INFORMATION	
PROPERTY RE: SUBMITTED: ARCHITECT: CONTACT:	1510 NE Multnomah St TYPE III DESIGN REVIEW LU 16-291413 DZ March 28, 2018 HOLST Dave Otte, Partner dotte@holstarc.com 503 233 9856
LANDSCAPE: CONTACT:	2.ink STUDIO Tommy Solomon, Associate tsolomon@2inkstudio.com 503 546 4645
OWNER: CONTACT:	Portland Lloyd Center Community LLC Cassidy Bolger bolger.cassidy@gmail.com 503 342 4903

SUMMARY OF UPDATES

LUR 2 - SOUTH LANDSCAPE PLAN RESPONSE

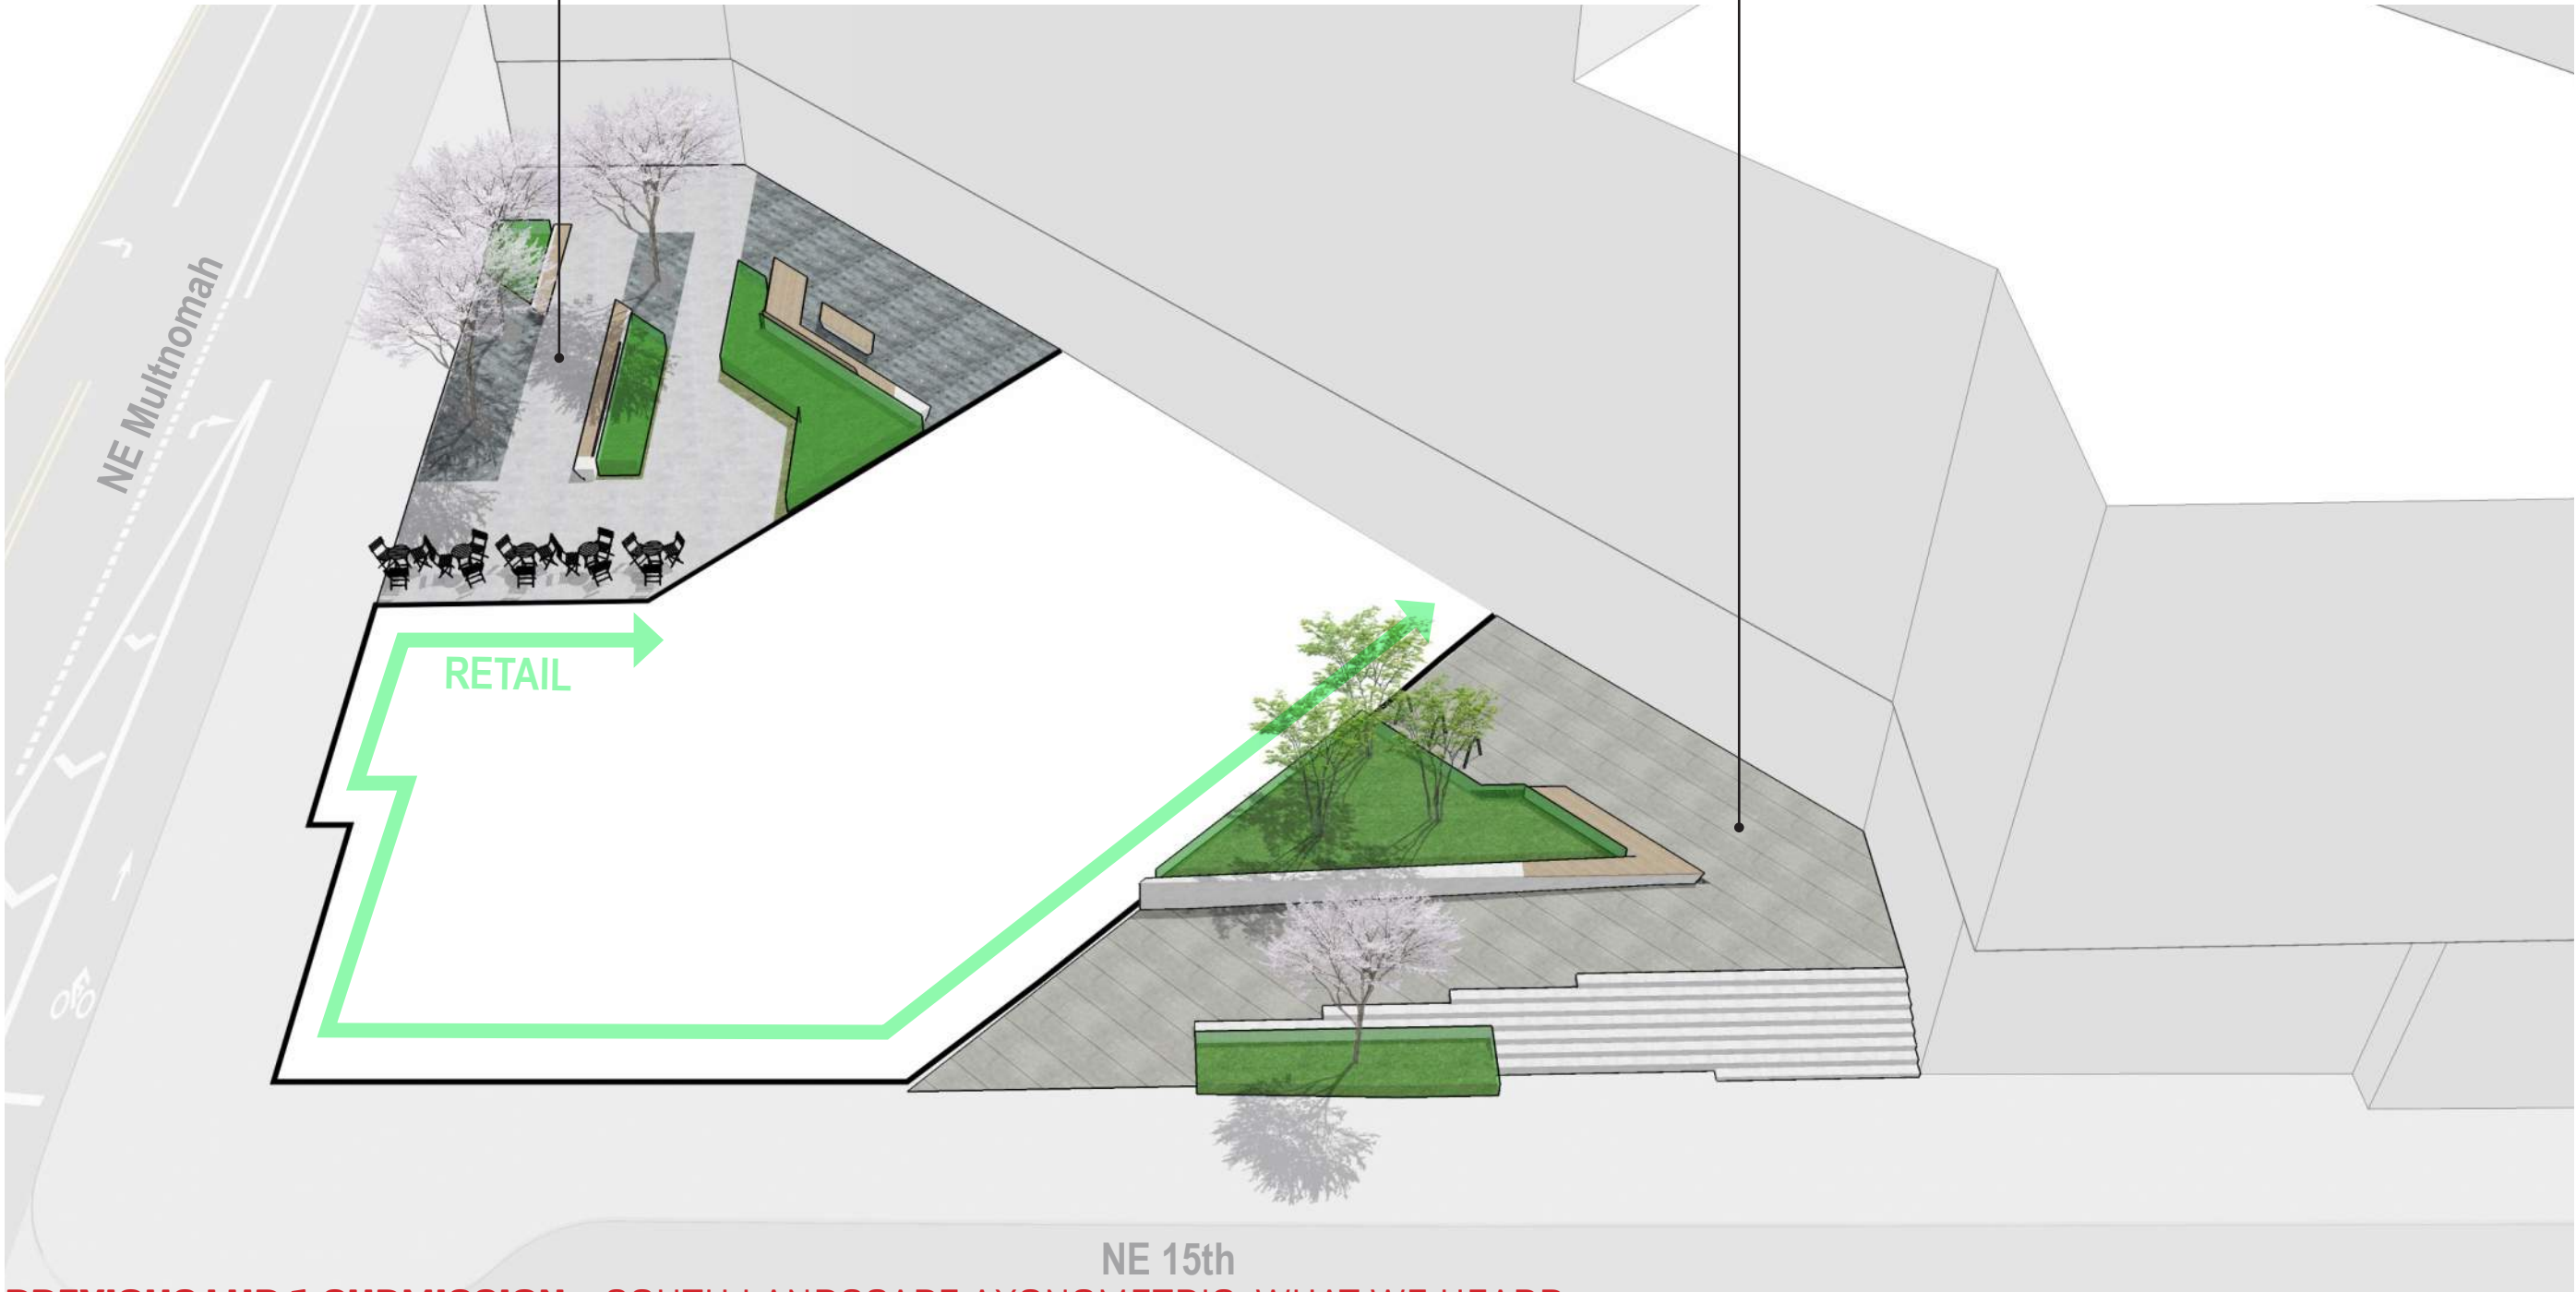
URBAN PLANE PLAZA
Courtyard layout and language doesn't seem quite 'baked'. Landscape design feels too tied to the geometry of the building - investigate some flexibility with layout language. Keep the benches.

PLATEAU PLAZA
Circulation path to Lobby seems too indirect. Linear bench feels like an obstacle and too sharp. Landscape design feels too tied to the geometry of the building - investigate some flexibility with layout language.

Landscape layout was simplified to create more flexibility of use and circulation throughout the space.

Landscape layout was simplified to create a more open terrace for the residential entry. Sharp points and barriers in the path of travel from 15th to the residential entry and retail back of house doors were eliminated.
